# UNITED STATES PATENT AND TRADEMARK OFFICE

<b>Office Action Summary</b>	Application No. 10/824,110	Applicant(s) EISENBRAUN, KENNETH D.	
	Examiner Amy J. Sterling	Art Unit 3632

This is the second non-final Office Action for application number 10/824,110 Merchandising Hanger, filed on 4/14/04. Claims 1-18 are pending. This is the second non-final Action is in response to applicant's Appeal Brief dated 10/19/05. The text of those sections of Title 35, U.S. Code not included in this action can be found in a prior Office action.

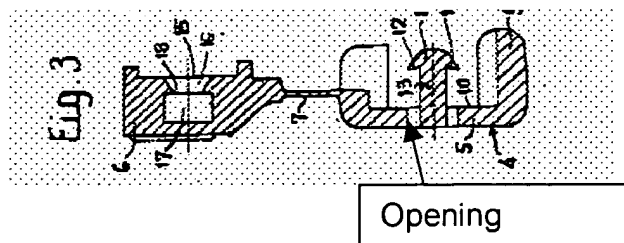
Claims 1, 3 and 9 are rejected under 35 U.S.C. 102(b) as being anticipated by United States Patent No. 3708835 to Bienz.

The patent to Bienz teaches a hanger (See Figure 3) having a planar surface (20) having a top and a base, a tab (4) extending from the base having a stud (13) integral with a third tab portion (5) and an aperture (15) having a flange (18) therein through the first tab portion (6), and a second tab portion (7) intermediate the first and third tab portions, wherein the second tab portion (7) has a thickness that is less than the first tab portion (6) and the first tab portion has a thickness that is greater than the third tab portion (5) and wherein there is an opening (See Drawing Below) adjacent the base of the stud in the third tab portion.
